**RE: Permit No. M-1980-244; Cripple Creek & Victor Gold Mining Company; Cresson Project;
Technical Revision 128 – Ironclad Facilities Access Road Re-Alignment**

CC&V ACCESS ROAD RE-ALIGNMENT ISSUED FOR CONSTRUCTION APRIL 29, 2021

PROJECT	CC&V ACCESS ROAD RE-ALIGNMENT	
	TITLE	
SITE PLAN	FILENAME	106.052.001M
	DRAWING NO.	A05
	REVISION	0

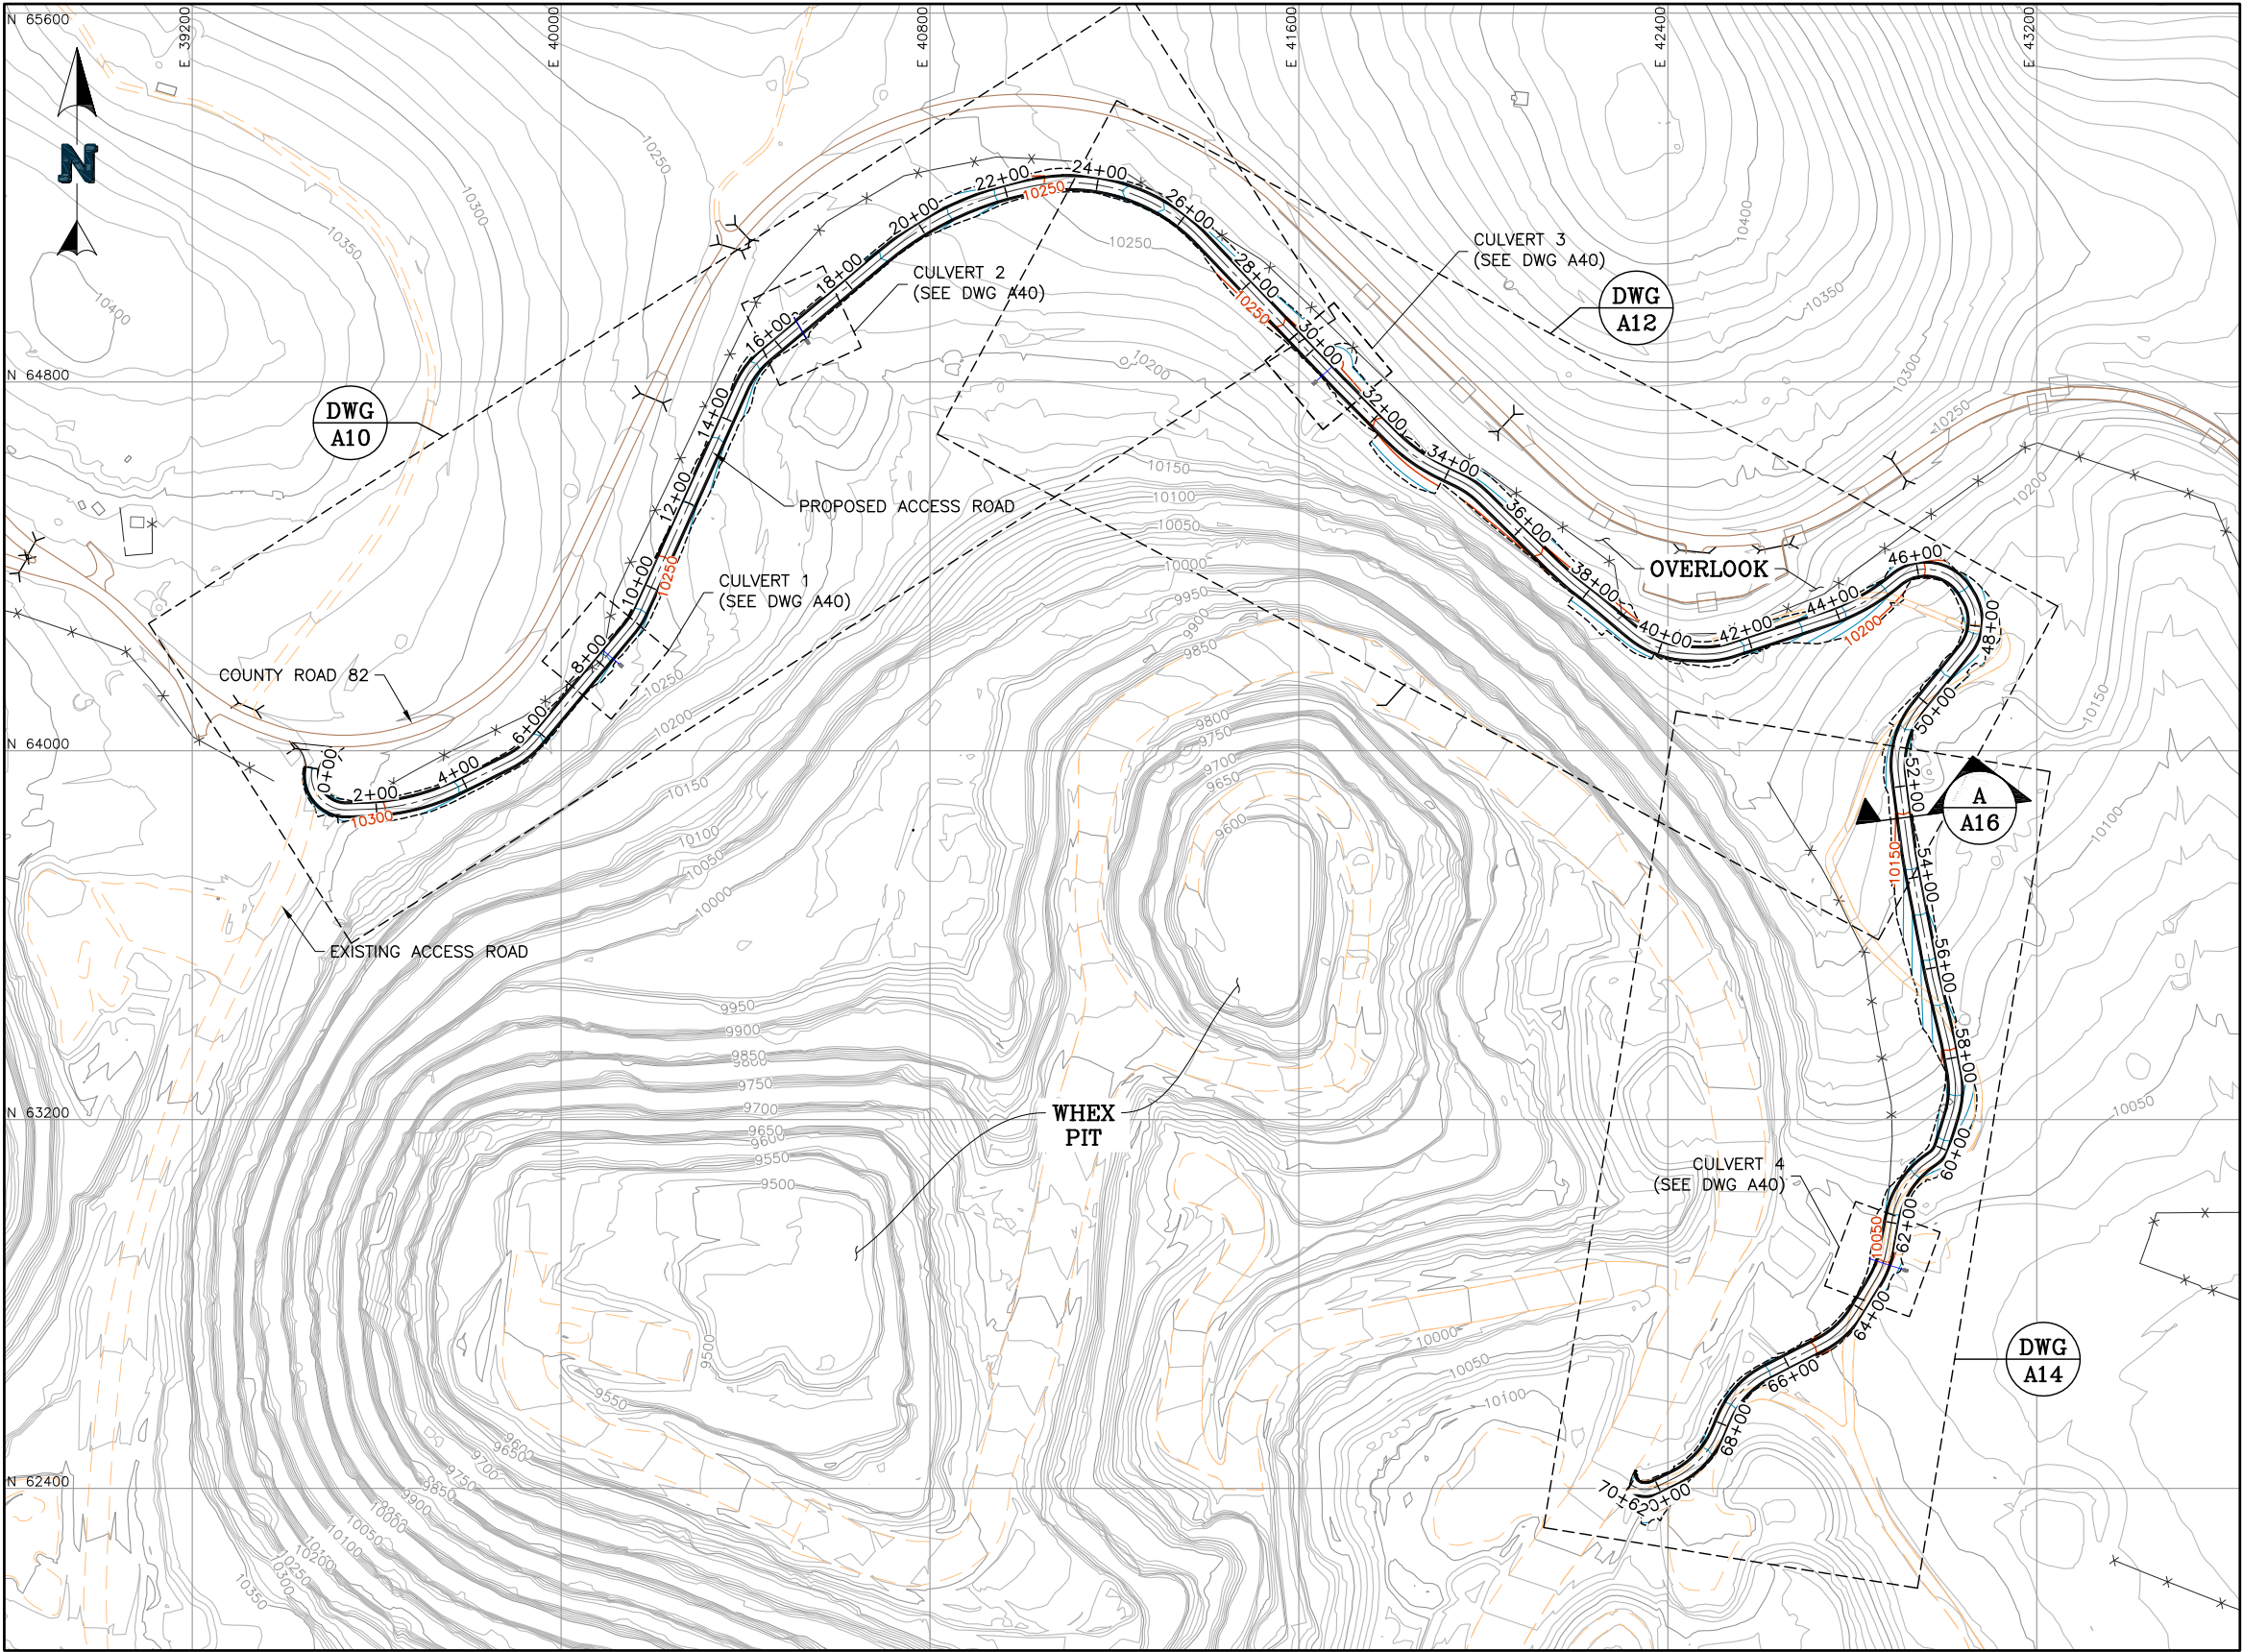
The location of the access road re-alignment is shown on Drawing A05, *Site Plan*, provided in the attached IFC drawing package. Drawings A10, A12, A14, and A16 show segments of the new access road alignment plan and profile. Generally, the re-alignment is located south and parallel to CR 82, around the northeastern side of the WHEX Pit. The new roadway alignment is approximately 7,000 feet long (1.3 miles) in total and 26 feet wide. The amount of material required to place for structural fill to create the desired road alignment will be approximately 25,600 cubic yards. Cut material from construction will be utilized for approximately 24,500 cubic yards of the desired fill, with approximately 1,100 cubic yards of fill material purchased and delivered to site by a third party contractor. The access road will be constructed utilizing both CC&V's internal resources and equipment as well as a third party contractor.

Four new culverts will be constructed to manage stormwater for the access road re-alignment. The location of these culverts are shown on Drawing A05 and details for each culvert are provided in Drawing A40. Riprap aprons, approximately 10 feet long and 6 feet wide, will be constructed at the effluent end of the culverts to mitigate erosion. A non-woven geotextile will be placed underneath the riprap apron. These culverts and riprap aprons were designed to manage approved surface water calculations in accordance with the Stormwater Management Plan. The Stormwater Management Plan maps and inspection templates will be updated accordingly upon construction completion.

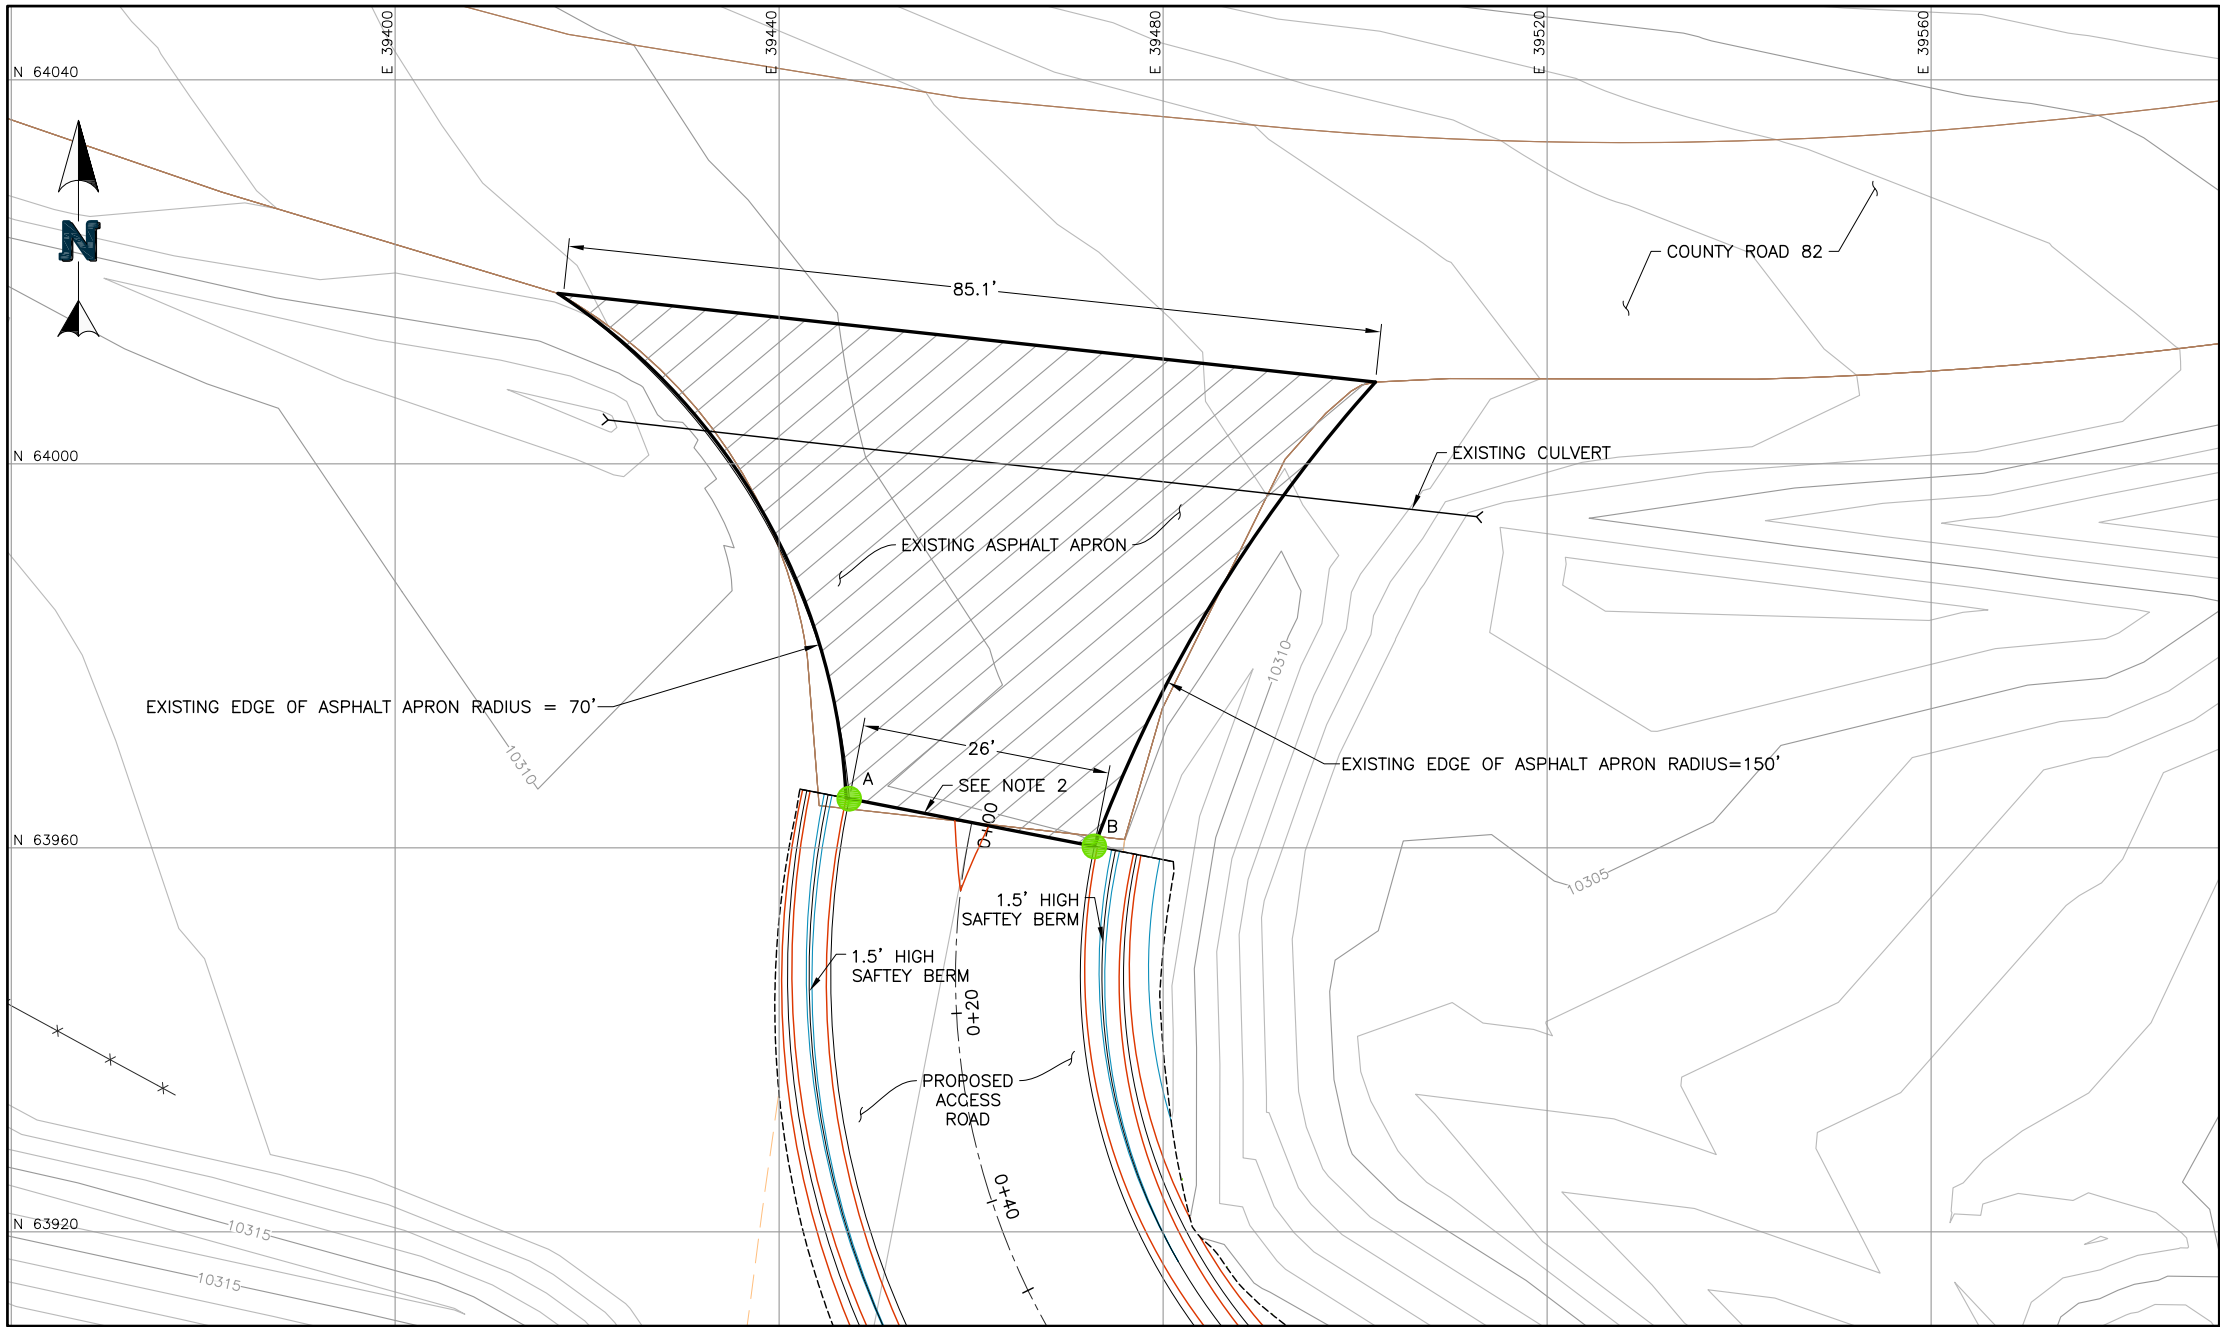
Drawings A20 and A30 show access road intersection construction details for the CR 82 and existing haul road intersections, respectively. Upgrades to CR 82 are not anticipated as the proposed access road will not increase any traffic to the public road, as discussed with Teller County Department of Transportation (TCDOT). The proposed access road will be constructed to meet requirements of a driveway, as specified by the TCDOT. Once construction is complete TCDOT will complete an inspection for approval to issue a Teller County Driveway Permit. The CR 82 intersection will tie into the existing asphalt apron connecting the current access road with CR 82. The new access road will be equipped with 1.5-foot high safety berms on both sides of the entire alignment.
